■ DOOR CHECK (FRONT AND REAR DOORS)

■ BACK DOOR LOCK

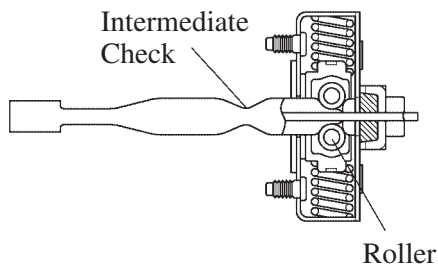
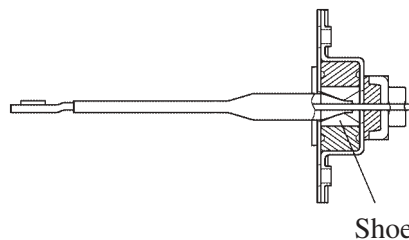
- The fitting construction of the door check to the body has been changed from the pin-fitted type to the bolt-fitted type. As a result, the appearance and the corrosion resistance of the area where the door check is fitted have been improved.
- The construction of the door check has been changed from the shoe type to the roller type to ensure the smoother operation of the door. In addition, an intermediate check mechanism to maintain the door open at the midway point has been provided for improved convenience.

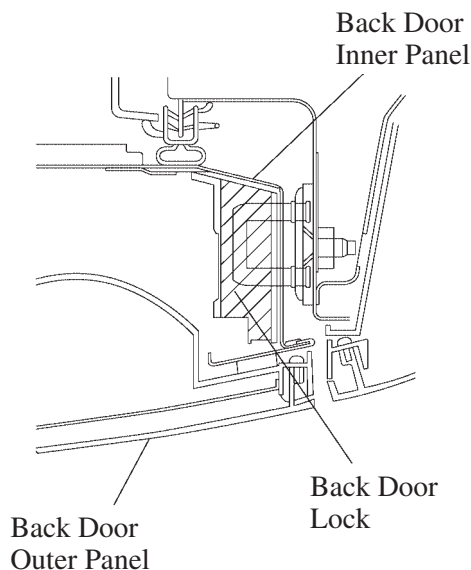
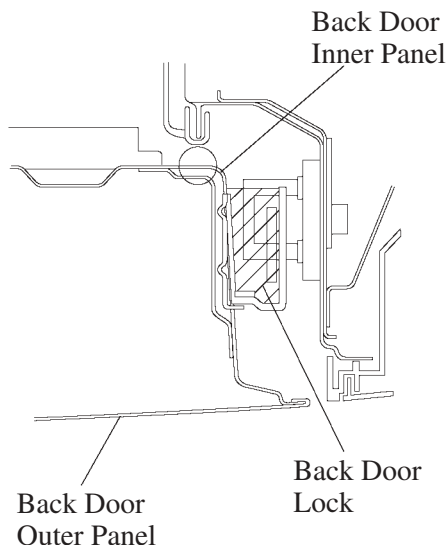
The position in which the back door lock is fitted has been changed from the outside of the back door to the inside of the back door. Also, the control mechanism of the back door lock has been changed from the link type to the cable type. As a result, the appearance of the back door lock area has been improved and the ease of use of the lock control has been improved.
